City of Greenville

Design Review Board – Neighborhood Panel

**Planning Staff Report to
Design Review Board - Neighborhood
July 29, 2022
for the August 4, 2022 Public Hearing**

**Planning Staff Report to
Design Review Board - Urban
July 29, 2022**
for the August 4, 2022 Public Hearing

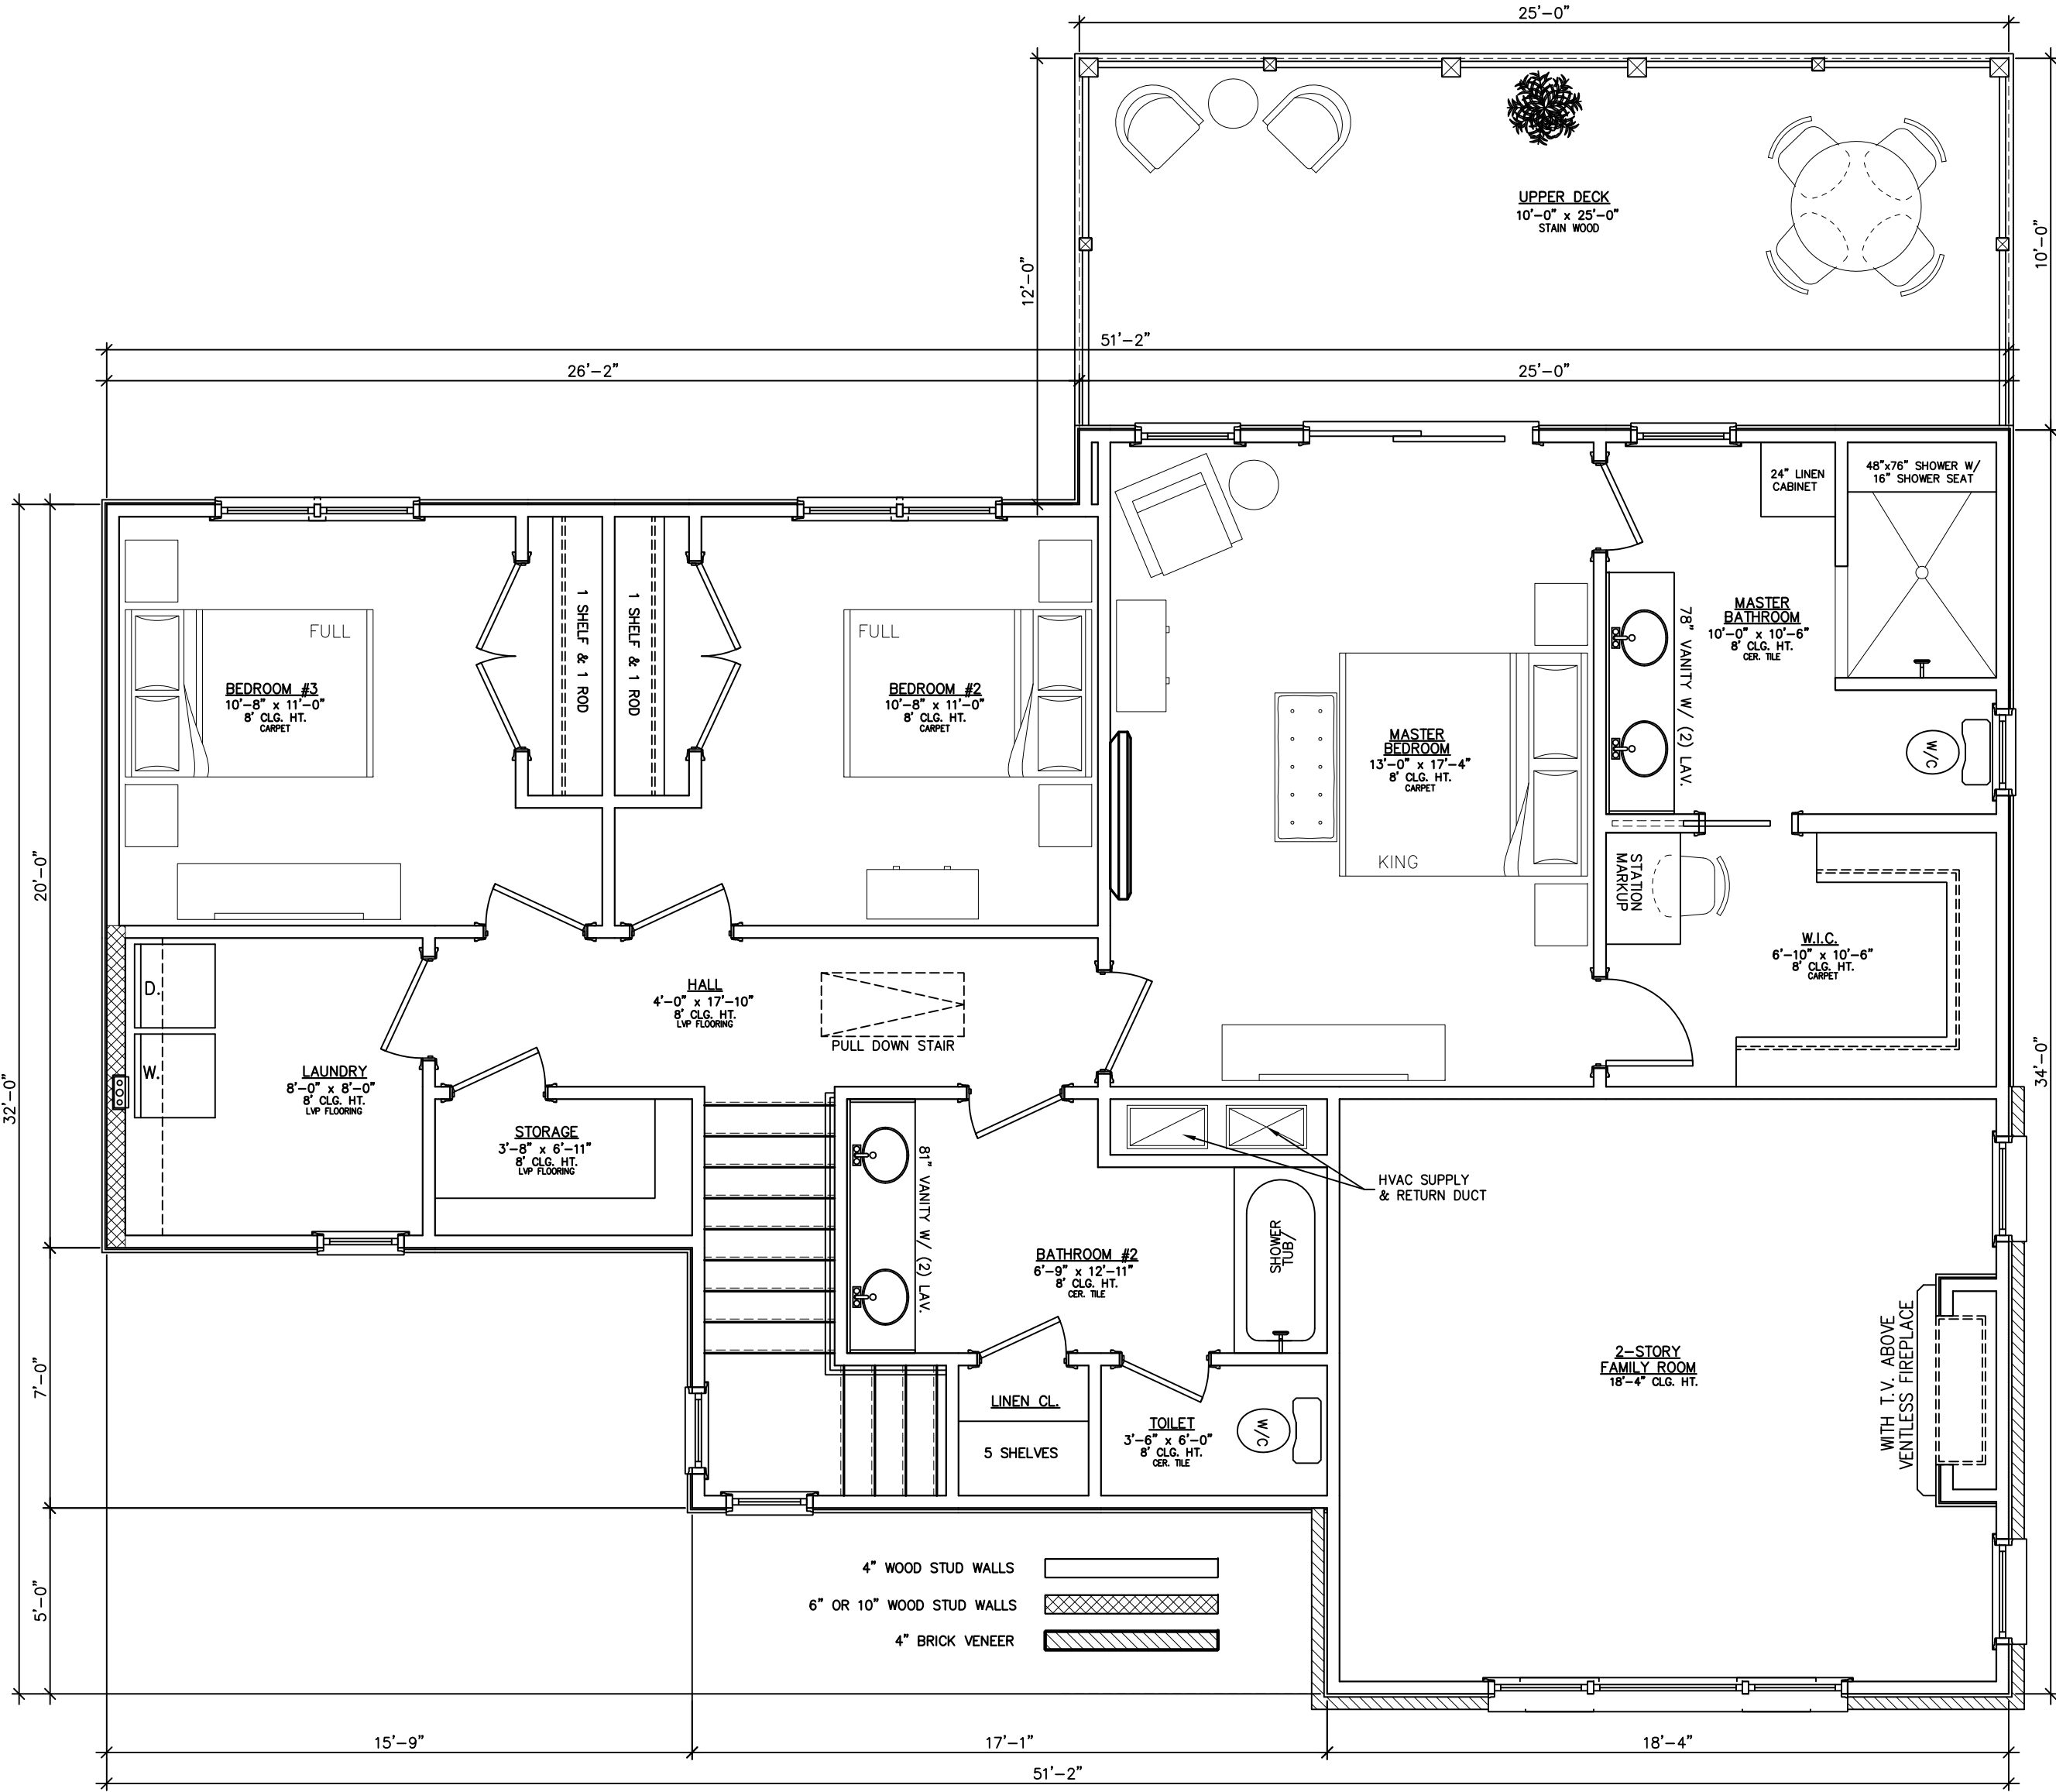
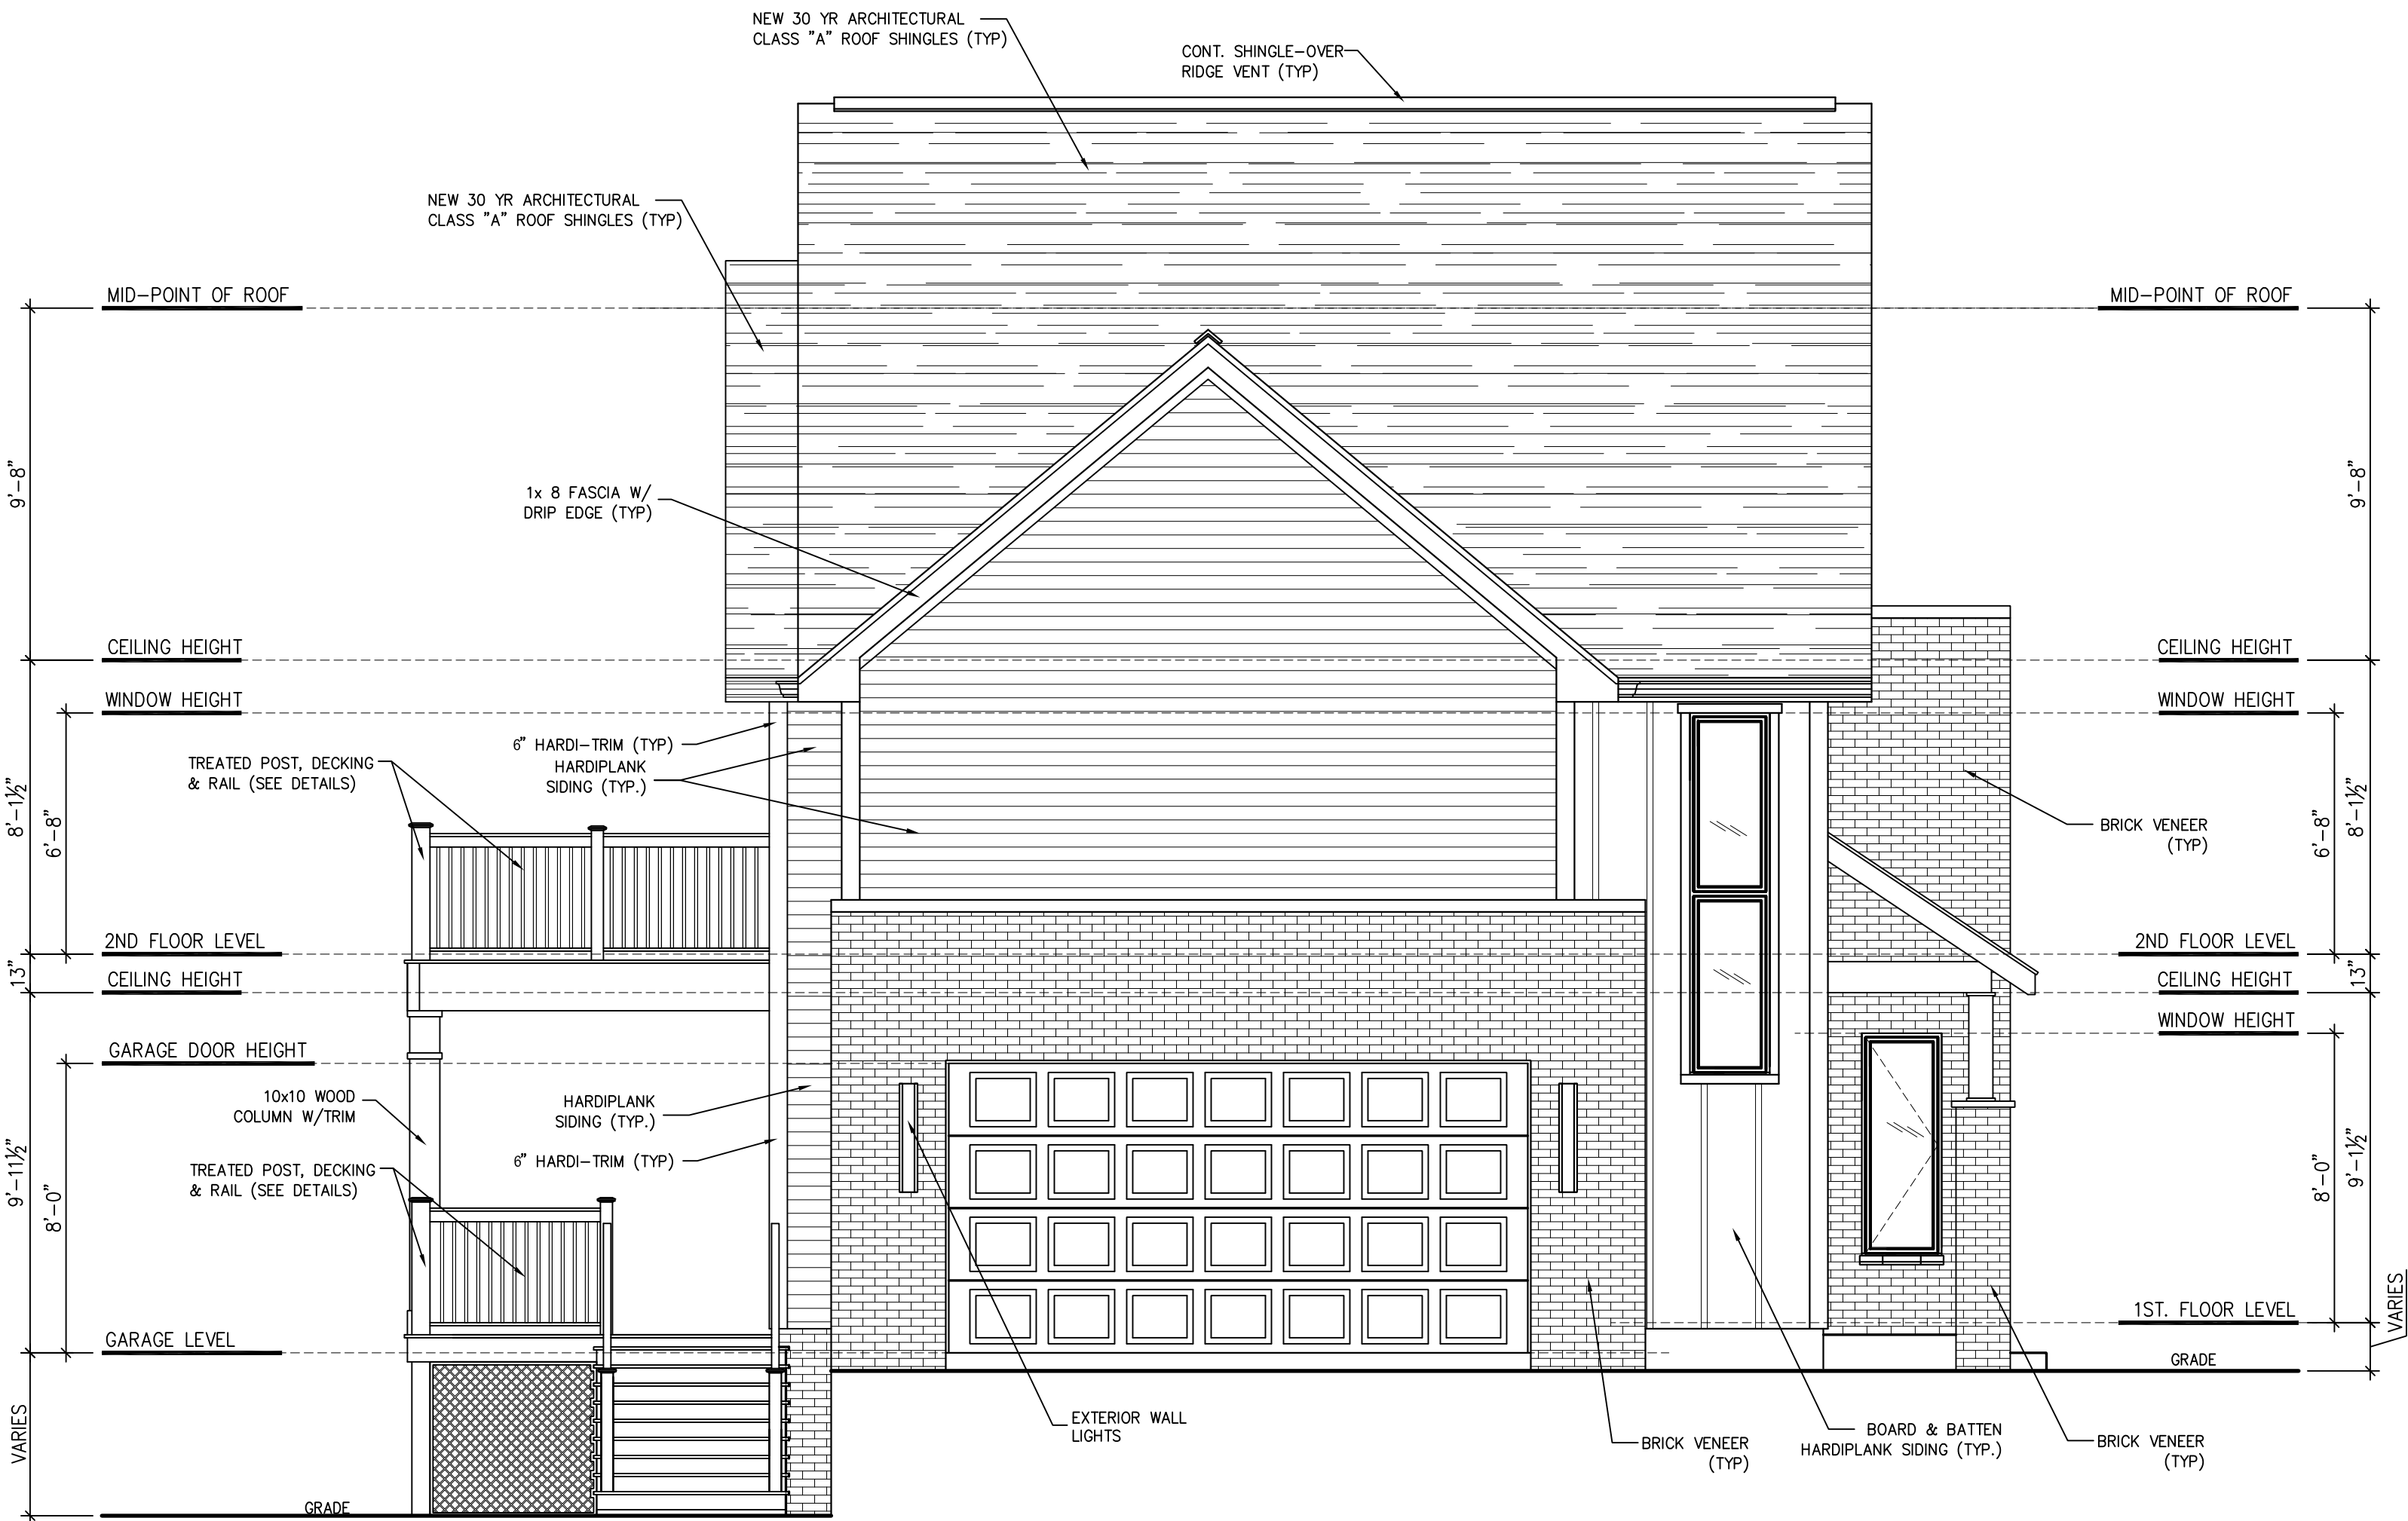
AR.9 recommends that new buildings, regardless of stylistic treatment, should appear similar in form and detail to houses in the area. A new building should be visually compatible. Staff finds that the overarching design of the structure emulates some of the fundamental similarities among the neighboring buildings. However, the bulking mass of the front-facing bump-out is not similar to any form seen in the neighborhood. Window spacing is not in line with that of traditional historic homes and should be adjusted. Additionally, buildings in the neighborhood sit on pedestals, not slab-on-grade, as is proposed.

As such, staff recommends **denial until the following modifications have been addressed:**

1. **Entry should be more prominent, with a larger porch.**
2. **Inclusion of a Chimney, as it is consistent with the common items found in the Overbrook District, and the floorplan shows a fireplace.**
3. **Reconsider dominance of the flat-roof. Flat-roofs should be used in fewer areas, especially the box-like bump-out which dominates the front façade.**
4. **Window size and spacing should be more consistent with traditional historic homes and shall be adjusted.**
5. **Structure should be on an elevated foundation, not slab-on-grade.**
